August 11, 2009
U7-C-STP-NRC-090095

South Texas Project
Units 3 and 4
Docket Nos. 52-012 and 52-013
Response to Request for Additional Information

RAI 01-12:**QUESTION:**

Figure 1: Postulated 2000-ft (Nominal) Breach Location Relative to Units 3 and 4 Construction Areas
(Source: modified from FSAR Figure 1.10S-1)

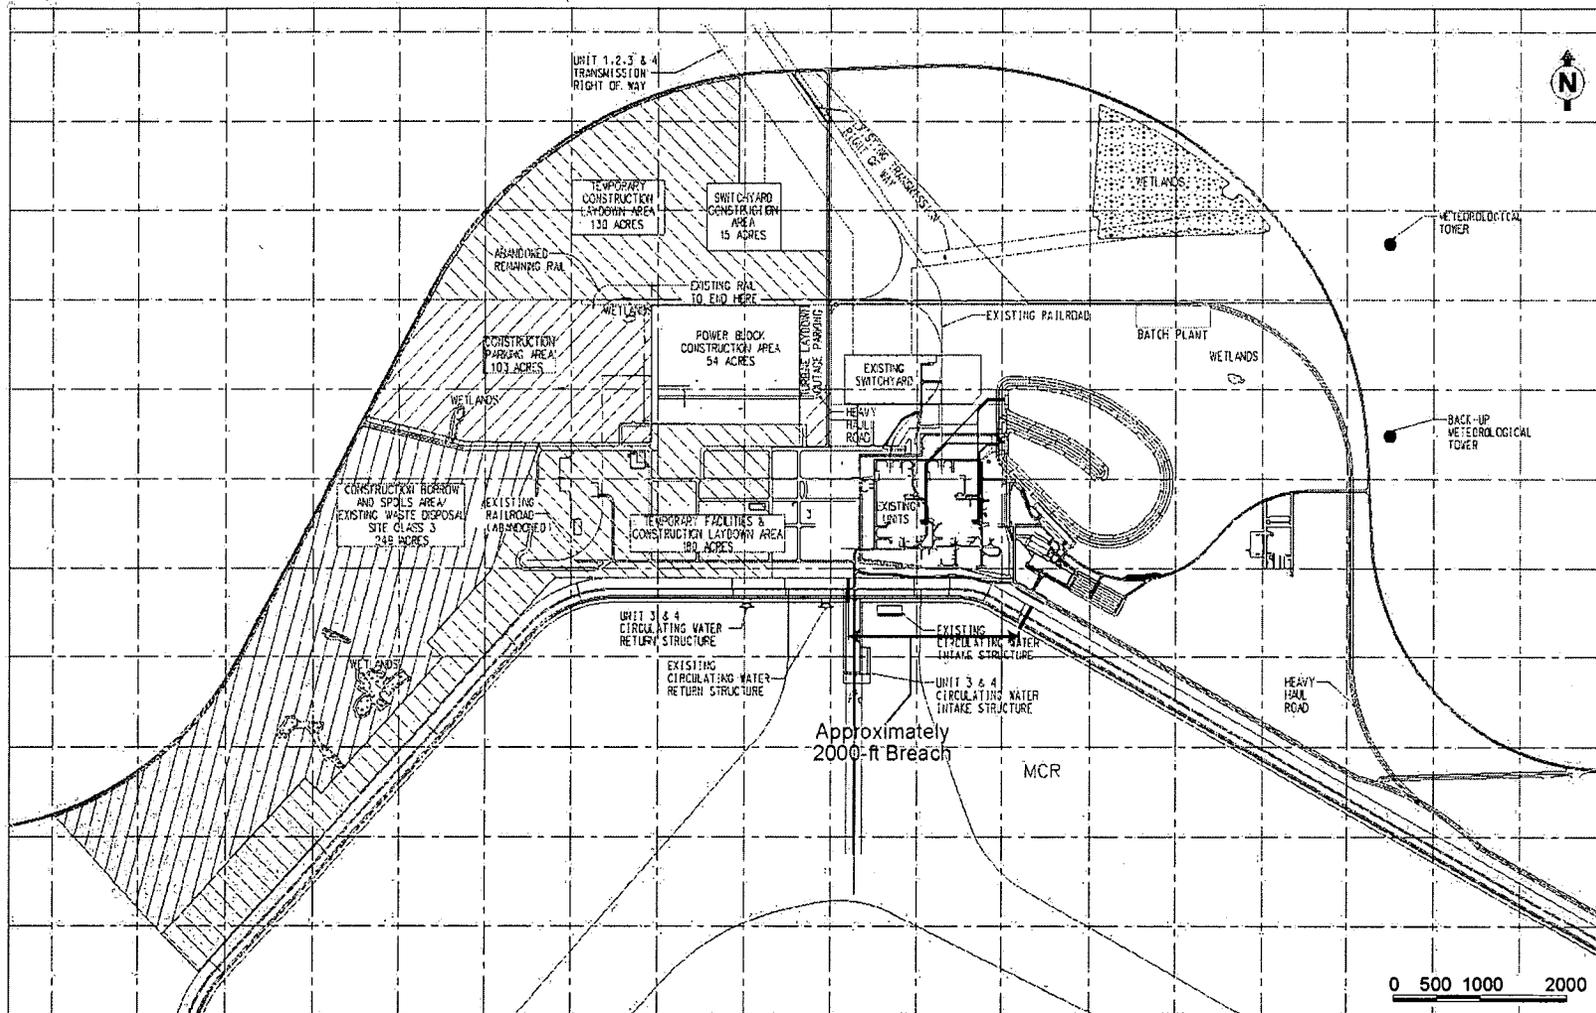
10 CFR 52.79(a)(31) requires that the COL applicant needs to evaluate the potential effects of construction activities of the proposed units on the safe operation of the existing units. The staff expects that the construction activities and the facilities of the proposed Units 3 and 4 could restrict the pathway of the MCR breach flood at the existing units and result in exacerbating the flooding level at units 1 and 2. However, the increasing of flood level and its consequence are not addressed in the FSAR Section 1.10. Therefore, the applicant should provide sufficient information to prove that there is no potential in increasing the flood level at the existing units. Or otherwise, the applicant should (1) include the increase of flood level in existing units as one of the potential construction hazards and (2) provide either managerial and administrative controls to protect from the potential flood hazard or evidence that the existing units 1 and 2 have already proper flood mitigation measures to cope with the increase of flood potential.

The construction activities and facilities for the proposed STP Units 3 and 4 are not expected to impact the design basis flood level that has been established for STP Units 1 and 2. This is primarily because the construction areas of Units 3 and 4, as shown in the construction facilities plan in Figure 1, are located at a distance of over 600 feet away from the approximately 2000-ft (nominal) breach opening postulated on the north embankment of the Main Cooling Reservoir (MCR) for the design basis flood level determination for Units 1 and 2, and are outside the predominant pathway of the flood wave from the breach.

The postulated MCR breach event and the related flood analysis for Units 1 and 2 are described in Subsection 2.4.4 of Revision 13 of UFSAR for Units 1 and 2 (Reference 1). As described, the prediction of the maximum flood elevation resulting from a failure of the MCR embankment was accomplished by using a two-dimensional computer model entitled "System 21" developed by the Danish Hydraulic Institute (DHI). The model simulated the propagation of flood wave and the impact on the structures of Units 1 and 2. The model predicted that the maximum wave run-up level (or instantaneous maximum water level) in the power block of Units 1 and 2 would be 50.2 ft NGVD 29 and would be caused by a critical breach width of 2000 feet (nominal) as shown in Figure 1. The maximum wave run-up would occur at the south face of the Units 1 and 2 power block structures, which is about 600 feet north of the failed embankment, at 38 seconds after the postulated breach. After impacting the power block structures of Units 1 and 2, the flood wave would continue to spread and propagate outwards to the downstream areas. Structures located on the flood path would cause wave reflections that may potentially travel back to the Units 1 and 2 power block area. However, with the Units 3 and 4 construction areas located outside the predominant path of the flood wave, at over 600 feet away from the breach opening and over 1000 feet away from the safety-related structures of existing units, there is no potential for the maximum wave run-up level at the existing units to be affected as any wave reflection from the construction facilities of Units 3 and 4 will arrive much later, more than 38

seconds, after the first wave impacted on the south face of Units 1 and 2 power block structures. In the quasi-steady condition, the backwater effect causes the maximum flood level predicted at the south face of Units 1 and 2 power block structures to be slightly higher at 50.8 ft NGVD 29, which has been adopted as the design basis flood level for the existing units. Model sensitivity test runs (Reference 1) indicate that the flow characteristics around the plant structures of Units 1 and 2 change insignificantly with changes in downstream boundary depth. For instance, the change on the water levels at the structures of Units 1 and 2 is found to be 0.3 ft or less in response to a 3-ft change in downstream water depth. Any potential increase in the water levels outside of the Units 1 and 2 power block during a breach event as a result of flow restrictions caused by the construction activities and facilities of Units 3 and 4 would be small because the area to the north and east of the Units 1 and 2 power block is wide open with few flow restricting features and generally low flow velocities, and would therefore, have minimal influence on the water levels at Units 1 and 2.

In addition, multiple levels of compounding conservatisms were employed in the Units 1 and 2 flood simulations as explained in Subsection 2.4.4 of Reference 1. Most significantly is the use of an extremely large breach width of 2000 feet (nominal). According to geotechnical and seismic evaluations discussed in Subsection 2.4.4.1 of Reference 1, the most conservative approximation of the improbable failure of the embankment would be the total, instantaneous removal of a 400-ft segment of the embankment. Using the 2000-ft breach (nominal) width in the design basis flood level determination for Units 1 and 2 introduces a “freeboard” of approximately 5.9 feet between the conservative 400-ft (nominal) breach scenario and the extremely conservative 2000-ft (nominal) breach scenario. Potential perturbations on the water levels in Units 1 and 2, during an embankment breach event, as a result of the construction activities and facilities of Units 3 and 4, if any, would be small and be sufficiently bounded by the 5.9 feet freeboard.

Since the design basis flood level for Units 1 and 2 is not expected to increase as a result of construction activities and facilities for Units 3 and 4, the existing flood mitigation measures for Units 1 and 2 are sufficient and no additional managerial and administrative controls are deemed necessary.
